Hoskins • Western • Sonderegger, Inc.
 PO Box 80358 825 J Street
 Lincoln, Nebraska 68501
 402/475-4241

REFERENCE: EPA Aquifer Exemption Hearing for Uranium Mining Permit
 Application for Wyoming Fuel Company

This letter is to provide comments for the EPA hearing to be held June 21, 1984 in response to the exempted aquifer petition submitted by Wyoming Fuel Company.

FIGURE 1

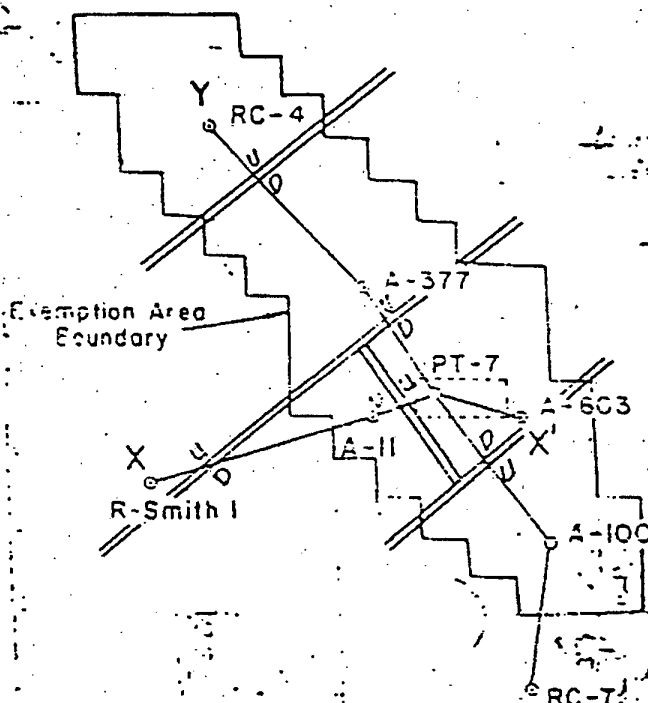
3. Wyoming Fuel has not shown that the lower Chadron is a separate unit of the Regional aquifer which includes the Chadron and the Brule. If the lower Chadron is hydraulically connected with the Brule, any injection would "endanger drinking water sources" which is a violation of Title 40, Chapter 1, Subpart A, 144.1(e).

We have prepared an alternate geologic interpretation (Figures 1 and 2 of this letter) based on the Wyoming Fuel data submitted in the exemption petition. The alternate interpretation is a physical model which includes faults to explain changes between bore holes. Faults are known to occur in the region in connection with springs. Thus the fault fractures play an important role in the flow system by providing upward movement along faults. The best example of this is the large spring (1,000 GPM) at Fort Robinson State Park located about 6 miles west of Boring numbered PT-7. Numerous smaller springs occur in the area northwest to northeast of Boring numbered PT-7. It is possible that the disruption of groundwater flow by faulting caused the uranium ore to be deposited in the first place.

The burden of proof is on the mining company to show that the Lower Chadron is isolated from the remainder of the Regional Aquifer. The pump test was of limited scope. It would prove isolation of the Lower Chadron only out to a distance of 1/2 mile from the tested well. It is possible that the proposed Research and Development area is situated on one isolated fault block. Under this condition it would meet the criteria.

Additional pump tests of longer duration and over extended areas are needed to map the extent of the isolation of the Lower Chadron. Geophysical prospecting can detect zones of fractures. Angle-drilled holes across suspected fractures could provide locations for in-place permeability tests which could show the existence of vertical permeable zones which would connect all the geologic units into one aquifer.
